# Access Design Report

**1 TRACEY AVENUE  
CARLINGFORD  
NEW SOUTH WALES**

**REPORT PREPARED FOR:  
DBG  
PROPOSED EARLY LEARNING CENTRE**

**REF# ADR2023.102B  
MAY 2023**

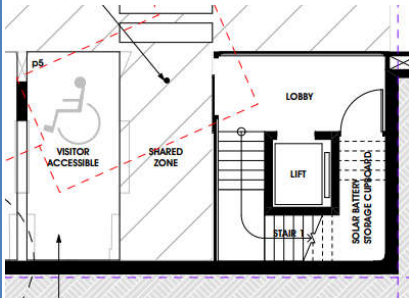
(1) An accessway required to be accessible must be provided from (a) The main pedestrian entry points at the allotment boundary (b) Any other accessible building connected by a pedestrian link (c) any required accessible carparking space on the allotment	<b>Yes</b>	<p>Accessible pedestrian access is proposed from Tracey Ave. Due to the site topography and building height setting a platform lift will link footpath level and Ground Floor level.</p>  <p>Main Pedestrian Entry</p>

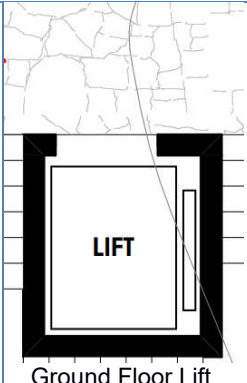
BCA Clause	Requirement	Compliance	Comments
	<p>1000 persons but not more than 2000 persons, 35 receivers            plus 1 receiver for every 50 persons or part thereof in excess of 1000 persons; and            (iv) if the room or space accommodates more than 2000 persons, 55 receivers plus 1 receiver for every 100 persons or part thereof in excess of 2000 persons.            (3) The number of persons accommodated in the room or space served by an inbuilt amplification system must be calculated according to D2D18.            (4) Any screen or scoreboard associated with a Class 9b building and capable of displaying public announcements must be capable of supplementing any public address system, other than a public address system used for emergency warning purposes only</p>		
<b>D4D9</b>	<b>TACTILE INDICATORS</b>		
	<p>(1) For a building required to be accessible, tactile ground surface indicators must be provided to warn people who are blind or have a vision impairment that they are approaching—            (a) a stairway, other than a fire-isolated stairway;            (b) an escalator;            (c) a passenger conveyor or moving walk; and            (d) a ramp other than a fire-isolated ramp, step ramp, kerb ramp or swimming pool ramp; and            (e) in the absence of a suitable barrier—            (i) an overhead obstruction less than 2 m above floor level, other than a doorway;            (ii) an accessway meeting a vehicular way adjacent to any pedestrian entrance to a building, excluding a pedestrian entrance serving an area referred to in D4D5, if there is no kerb or kerb ramp at that point, except for areas exempted by D4D5.            (2) Tactile ground surface indicators required by (1) must comply with sections 1 and 2 of AS/NZS 1428.4.1.            (3) A hostel for the aged, nursing home for the aged, a residential aged care building, Class 3 accommodation for the aged, Class 9a health-care building or a Class 9c aged care building need not comply with (1)(a) and (d) if handrails incorporating a raised dome button in accordance with AS/NZS 1428.4.1 are provided to warn people who are blind or have a vision impairment that they are approaching a stairway or ramp.</p>	<b>It may comply</b>	Architect to note: TGSIs to main pedestrian stairs and stairs connecting Basement, Ground Floor & First Floor Level.

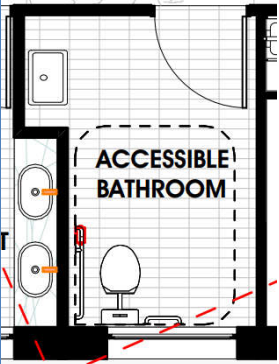
(b)	Lift floor dimension of not less than 1400 mm wide x 1600 mm deep which travel more than 12m	<b>N/A</b>	
(c)	Lift floor dimensions of not less than 1100mm wide x 1400mm deep when lift travel not more than 12m except a stairway platform lift	<b>Yes</b>	Architect to note & confirm

(d)	Lift floor dimensions of not less than 810 mm wide x 1200 mm deep for a stairway platform lift.	<b>N/A</b>	
(e)	Minimum clear door opening complying with AS 1735.12 for all lifts except a stairway platform lift.	<b>Yes</b>	Architect to note & confirm
